PacifiCorp - Stakeholder Feedback Form

2023 Integrated Resource Plan

***IRP Topic(s) and/or Agenda Items:** List the specific topics that are being addressed in your comments.
Qualifying Facilities

FIGURE 5
Correlated Outages for Natural Gas Generators by Cause During the ERCOT February 2021 Event

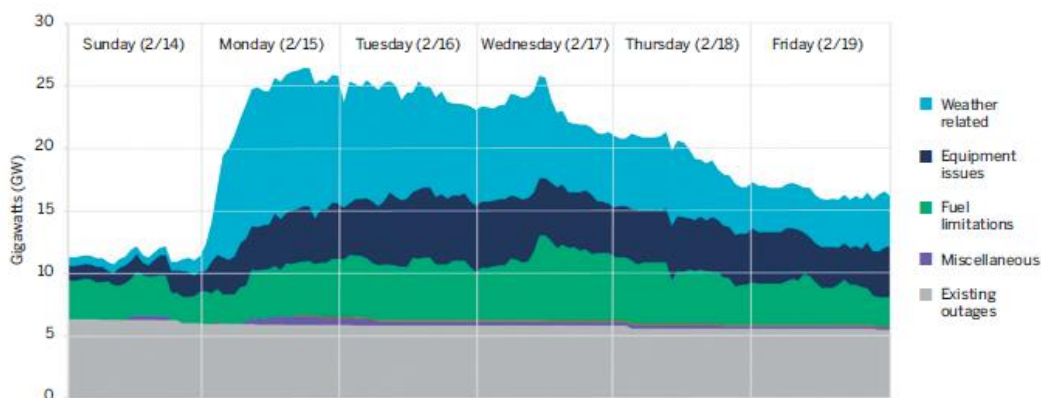
3. Coal and gas plants tend to have difficulty in extreme heat or cold. Thermal plants require more power to cool themselves in extreme heat, reducing the amount of power available to the grid.^{1,2} They also tend to trip off or go into forced outages during weather events. For example, during a May heat wave in ERCOT, about 3,000 MW of gas capacity tripped offline throughout the day, forcing requests for customers to reduce demand.³ During a February 2017 heat wave in Australia, 14% of coal and gas capacity was unavailable as a result of faults largely related to the heat.⁴ On PacifiCorp's system, Jim Bridger units have recently tripped during heat waves. Recently, FERC, PJM, and other RTOs have considered new ways to think about resource performance and capacity accreditation of thermal resources.⁵ New methods have been proposed to more accurately represent the reliability contribution of thermal generators by taking into account the distribution of system outages and potential correlations in outages across a generation fleet.^{6,7}

Increasingly, an average ‘Forced Outage Rate’ may not be representative of the actual reliability of thermal units.⁸

Please explain whether PacifiCorp has recently re-evaluated its calculation of capacity contribution/Forced outage rates for thermal generators.

- Has PacifiCorp recently considered whether improvements should be made to the capacity contribution or Forced Outage Rate calculation used in IRP modeling for thermal units?
- How has PacifiCorp accounted for the risks of thermal generation becoming unavailable during extreme weather in its calculation of capacity contribution/Forced Outage Rates for thermal units, especially as the likelihood of extreme weather events increases with climate change?

- 1.) No update is available regarding commercial agreements. Negotiations are ongoing.
- 2.) The 2023 IRP will not include take-or-pay pricing as a base model assumption for Huntington in consideration of the possible application of environmental clauses.
- 3.) While we have not adjusted our FOR assumptions, BHE has been complying with additional NERC requirements regarding extreme weather preparedness. PacifiCorp has always performed weatherization on the thermal plants, but weatherization measures/actions are now being formalized by NERC.
- 4.) FOR assumptions have not changed due to existing weatherization measures and improved extreme weather planning.
